Office Action Summary	Application No. 10/523,780	Applicant(s) MATSUOKA, HIROMUNE	
	Examiner Tatiana Delorm	Art Unit 3744

DETAILED ACTION

Fig. 1a

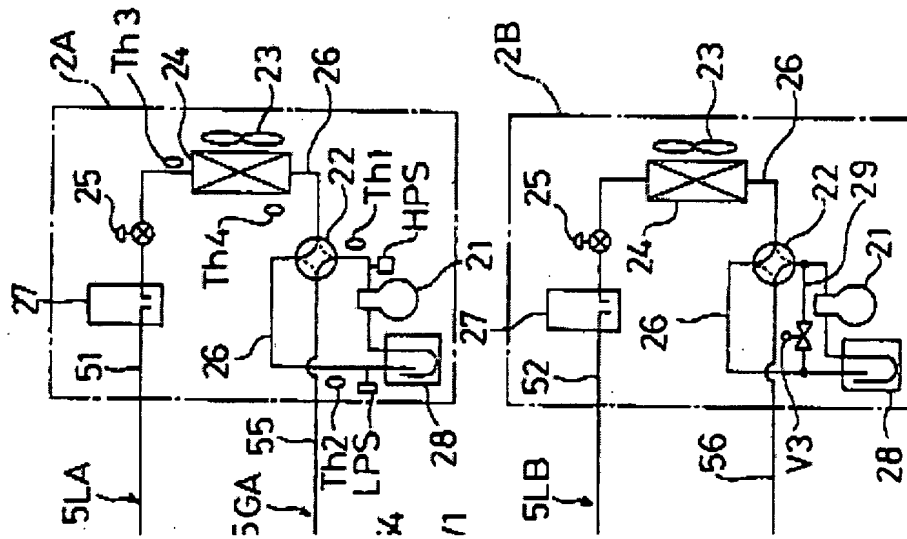
Sada teaches a plurality of utilization side (3A; 3B) heat exchangers (32) mutually connected (see lines 4L and 4G) in parallel (see Fig. 1) and arranged to operate as an evaporator (32); a switching mechanism (22) configured and arranged for switching between a state (Fig. 1); and a suction accumulator (col. 2, line 59) connected between said switching mechanism and the said inlet side of said compressor (see Fig. 1); said accumulator (28) connected between said switching mechanism and inlet side of said compressor (Fig. 1, col. 12, lines 1-3), said accumulator (28) configured and arranged for pooling low-pressure refrigerant (LPS) as a liquid refrigerant, said switching mechanism and the inlet side of the compressor forming a low pressure unit (as seen in the illustration of Fig.1a);

and the compressor, said heat source side heat exchanger, said plurality of utilization side heat exchangers, and said switching mechanism forming a high pressure unit (Fig. 1).
